# Access Compliance Report

## Public Rights-of-Way

Intersection ID: 43210	Main Street: ENDERLY_RD	Cross Street: MATHIS_DR	Location: S
ADA ID: 1AB9FA9B7EF3	Ramp Type: PerpDiag	Initial Pass/Fail: Fail	Overall Compliance: No
		Severity Score: 10

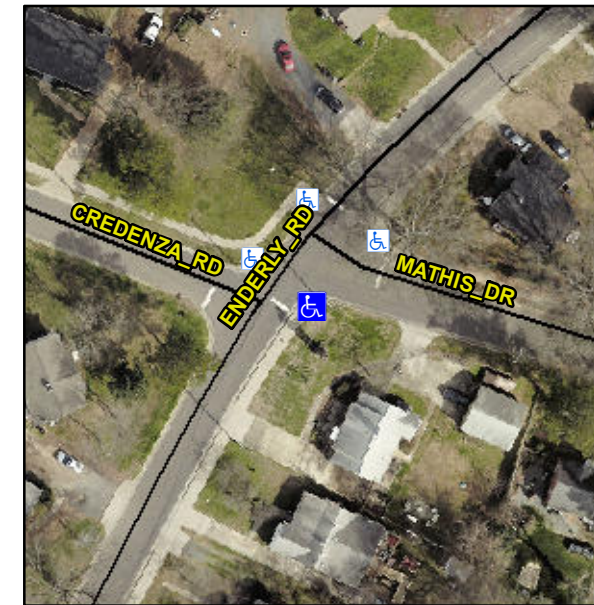
**R304.5.1, R304.5.3**

Compliance	Description	Data	Compliance	Description	Data
N/A	Ramp Length (in)	74.0	Yes	Ramp Slope (%)	5.5
No	Ramp Width (in)	43.0	No	Ramp XSlope (%)	4.2
N/A	Flare Type LT	N/A	N/A	Flare Type RT	N/A
N/A	Flare Slope LT (%)	N/A	N/A	Flare Slope RT (%)	N/A
N/A	Flare Traversable LT?	N/A	N/A	Flare Traversable RT?	N/A
N/A	Landing Length (in)	N/A	N/A	DWS Provided?	N/A
N/A	Landing Width (in)	N/A	N/A	DWS Contrast?	N/A
N/A	Landing Slope (%)	N/A	N/A	DWS Length (in)	N/A
N/A	Landing X Slope (%)	N/A	N/A	DWS Full Width?	N/A
N/A	Landing Curb? (Y/N)	N/A	N/A	DWS Offset (in)	N/A
N/A	Shared Landing?	N/A			
N/A	Gutter Ponding?	N/A	N/A	Gutter Slope (%)	N/A
N/A	Gutter Lip Ht (in)	N/A	N/A	Gutter X Slope (%)	N/A
N/A	Painted X Walk1?	No	N/A	Painted X Walk2?	No
	X Walk 1 Direction	To NE		X Walk 2 Direction	To NW
N/A	X Walk 1 Width (in)	N/A	N/A	X Walk 2 Width (in)	N/A
	X Walk 1 Slope (%)	5.3		X Walk 2 Slope (%)	0.3
	X Walk 1 X Slope (%)	3.2		X Walk 2 X Slope (%)	5.6

**Remove & Replace Curb Ramp With Two New Directional Ramps or Equivalent.**
